Date: July 23, 2024

RE: 3012 Bee Cave – Commercial Zoning and Drainage Review 3

Example:

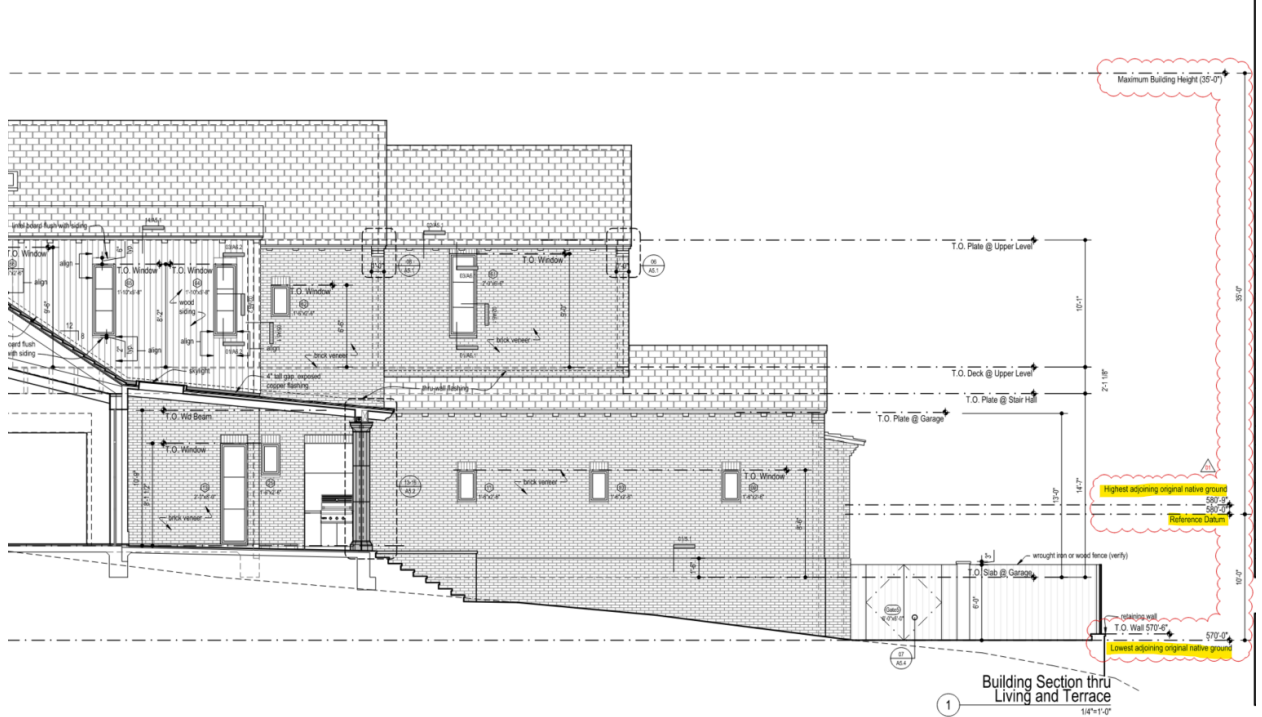
C2. Show reference datum per below referenced code. (see example exhibit attached)

C3. Identify the 594.9 lowest NG on the exhibit so that the reference datum (640.9) is easily understood as to why that is the maximum height reference point (see example of previously

accepted reference datum option 2). Update sheet A4.1 to reflect the changes of pitched roof along with same reference datum point per sheet A5.1
